HISTORIC AND DESIGN REVIEW COMMISSION

HDRC CASE NO: 2017-166
ADDRESS: 7615 KENNEDY HILL
LEGAL DESCRIPTION: NCB 10879 BLK 13 LOT 1 (BCB UT-20A & 20D)
ZONING: C-3
CITY COUNCIL DIST.: 3
DISTRICT: Brooks School of Aerospace Medicine Historic District
APPLICANT: Ignacio Rodriguez/McChesney/Bianco Architecture
OWNER: University of Incarnate Word
TYPE OF WORK: Extend existing parking lot and install rear screen
REQUEST:

The applicant is requesting a Certificate of Appropriateness for approval to:

1. Extend the existing circular drive parking to the northeast and northwest.
2. Modify existing dimensions and add delivery parking space to existing parking lot.
3. Construct an 8 foot tall permanent screen around a delivery area.

A2.0001 EXISTING NORTH PARKING LOT - WEST EXTENSION DEMOLITION SCALE: 1" = 10'

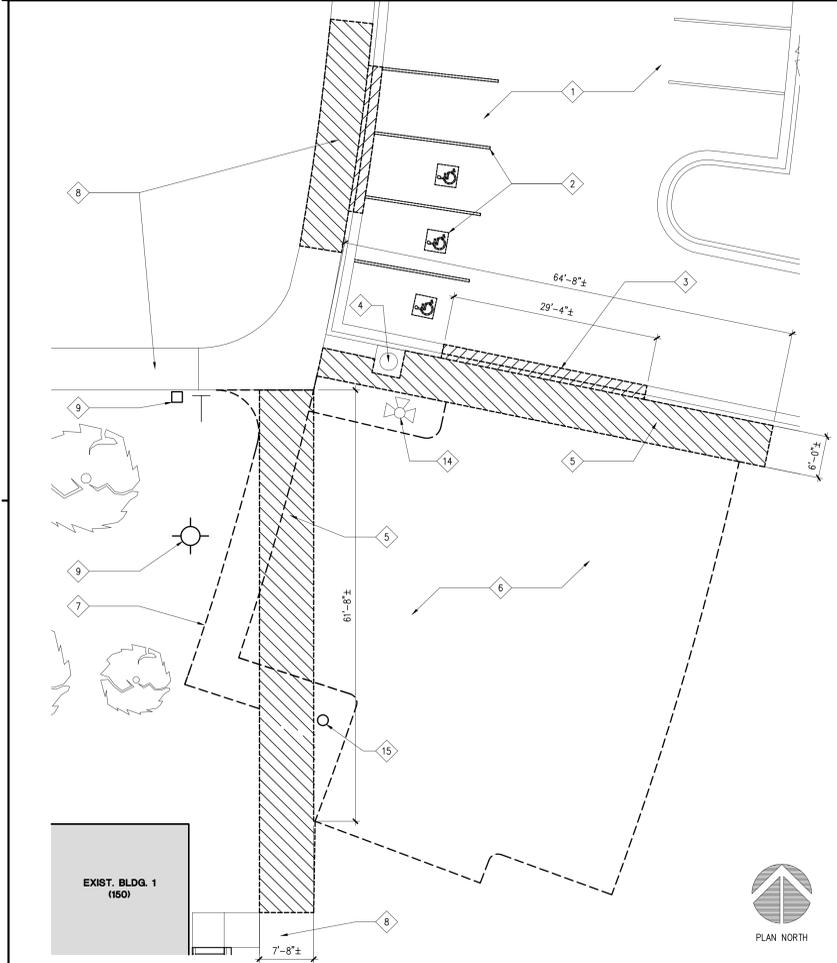
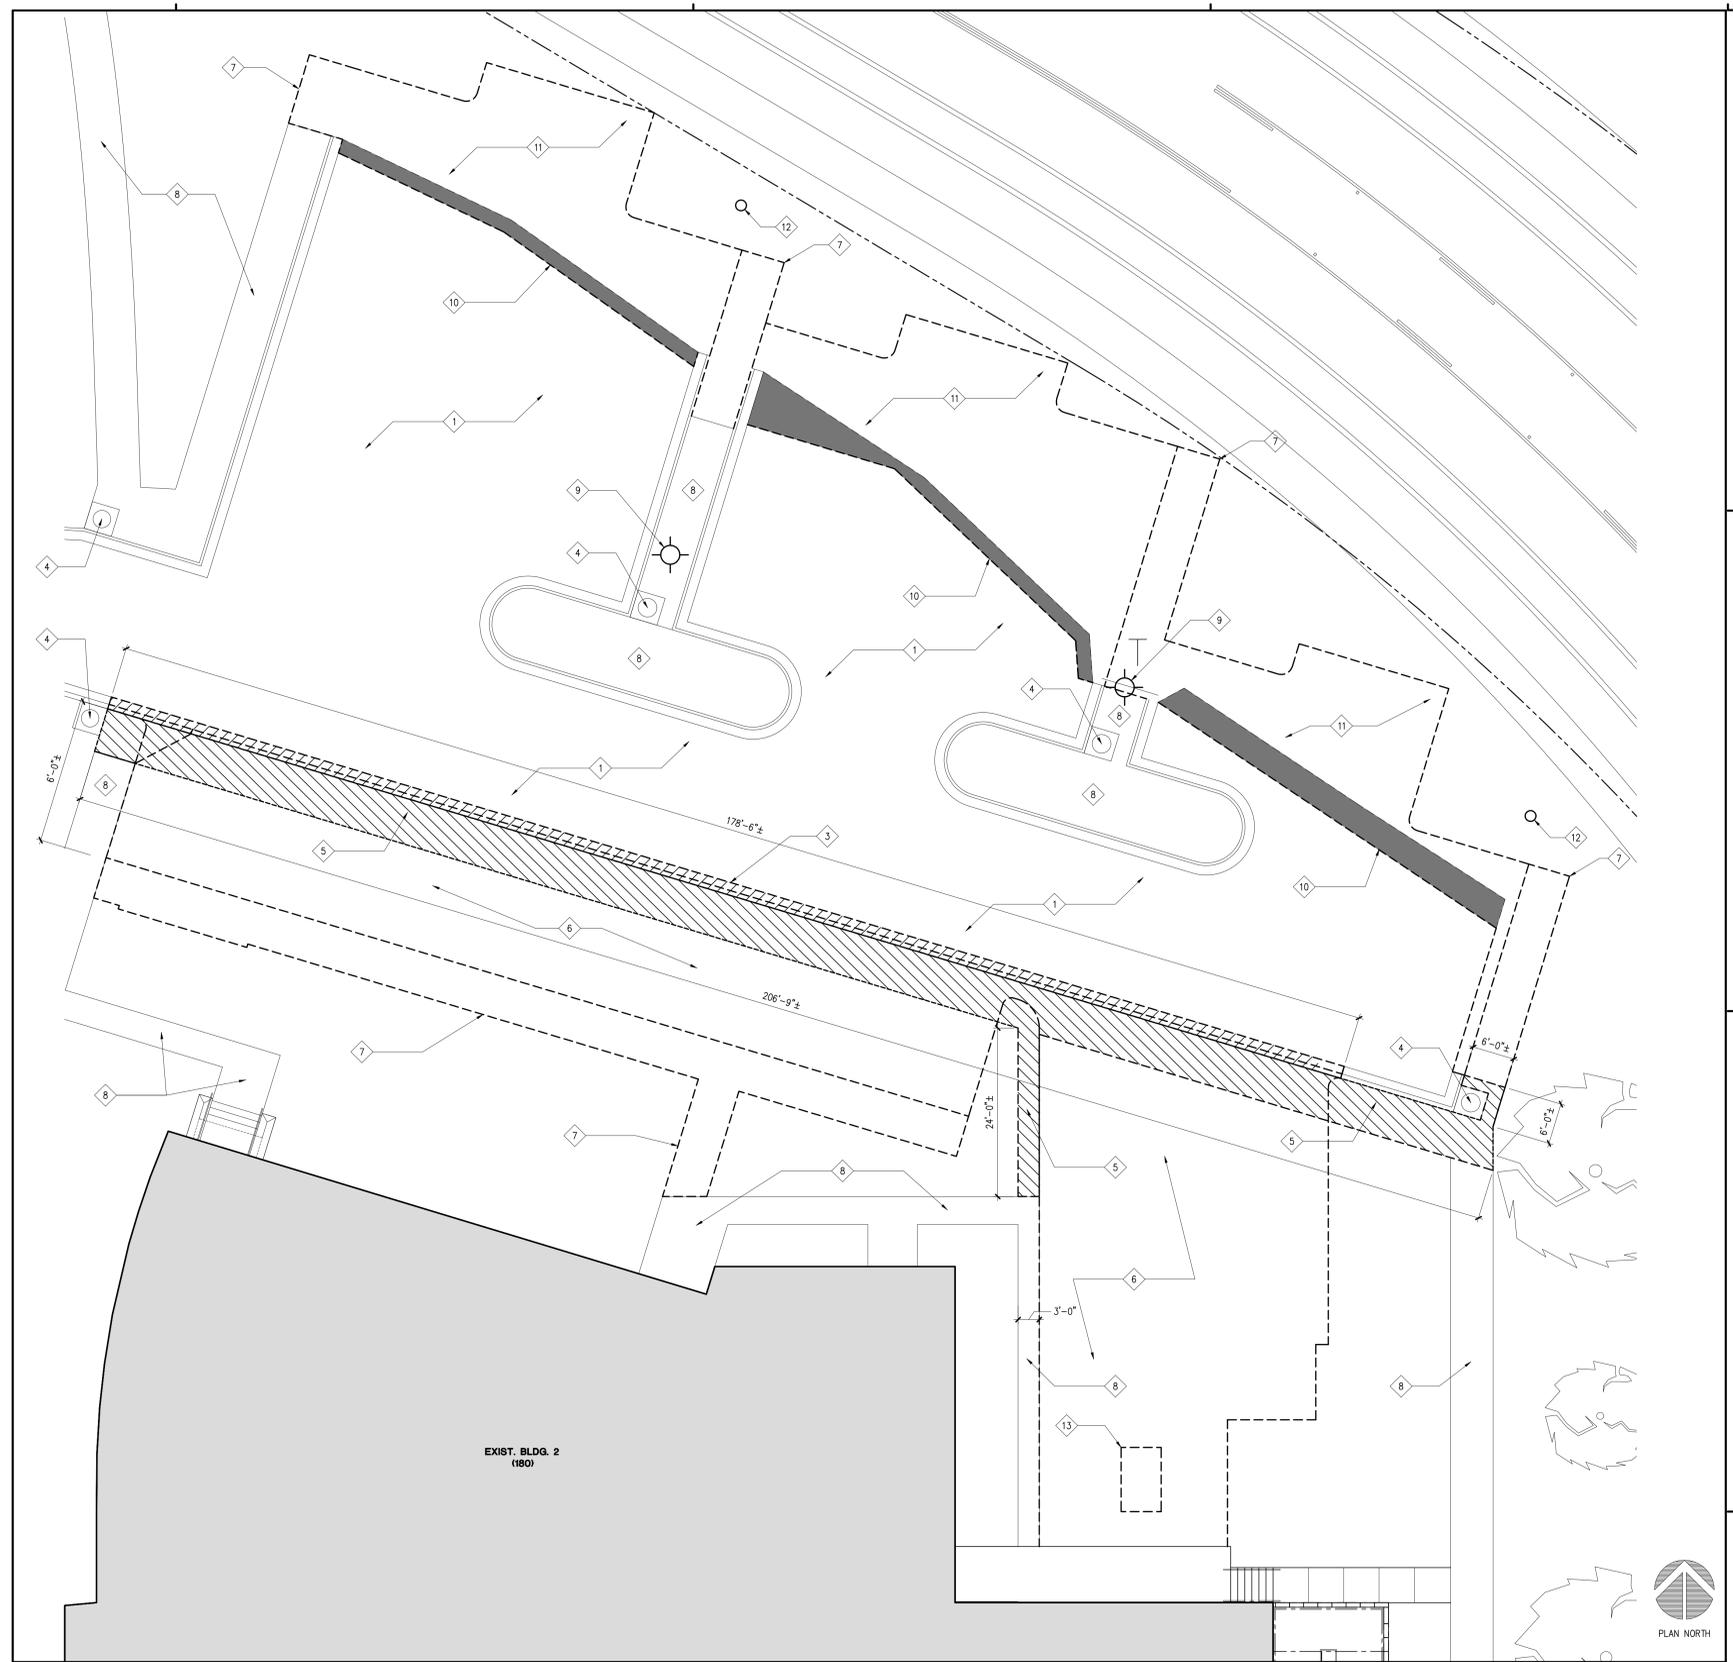
- b. **PARKING: CIRCULAR DRIVE** – The applicant has proposed to extend the semicircular drive parking areas to the northeast and northwest of Building 150, which is the anchor structure within the semicircular pathway. The semicircular drive and its internal semicircular parking ring are key character defining features of the campus street design as indicated in the district-specific Historic Design Guidelines. The new parking spaces would also require removal of existing sidewalks and grass that are essential components of the historic campus street design. Chapter 2 of the guidelines specifically states that new parking should not disrupt any historic landscape feature or spatial relationships within the campus. Staff finds the proposal inconsistent with the guidelines and the district Master Plan.

1. Staff does not recommend approval of the semicircular parking lot extension based on findings a and b.
2. Staff recommends approval of the parking lot modifications for Building 180 based on findings a and c. Staff encourages the applicant to incorporate guidelines emphasizing trees in the interior of the parking lot and parking screening with vegetation, found in Chapter 5 sections 5.A.2 and 5.A.5.
3. Staff recommends approval of the installation of a permanent screen based on findings a, d, and e with the following stipulation:
 - i. That the fence be made of terra-cotta brick per the School of Aerospace Medicine Historic District Guidelines. The applicant must submit the final design drawings and material specifications to staff before receiving a Certificate of Appropriateness.

PHOTO 3
PROPOSED WOOD FENCE CONCEPT

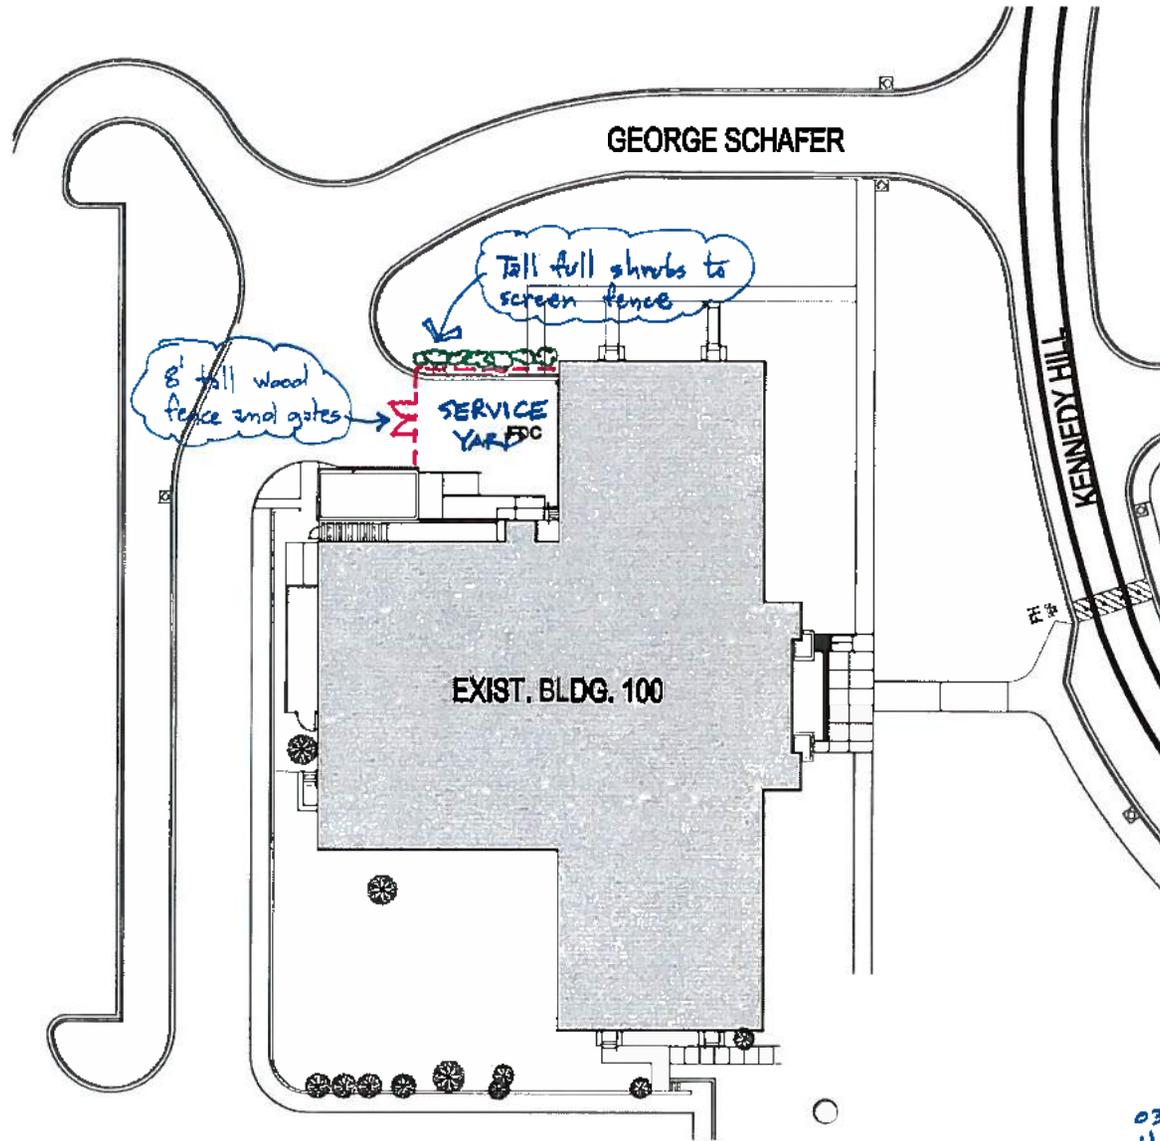
- e. **FENCE MATERIAL** - The applicant has proposed that the fence be constructed of wood slats. The district guidelines state that service areas were historically placed in areas that were visually unobtrusive and incorporated materiality that closely mimicked the materials of primary structures. According to the School of Aerospace Medicine Historic District Guidelines, all fences must be constructed of terra-cotta colored brick to retain the unobtrusive nature of service areas and their associated screening methods. Staff finds the use of wood inconsistent with these guidelines and recommends that terra-cotta colored brick be utilized.
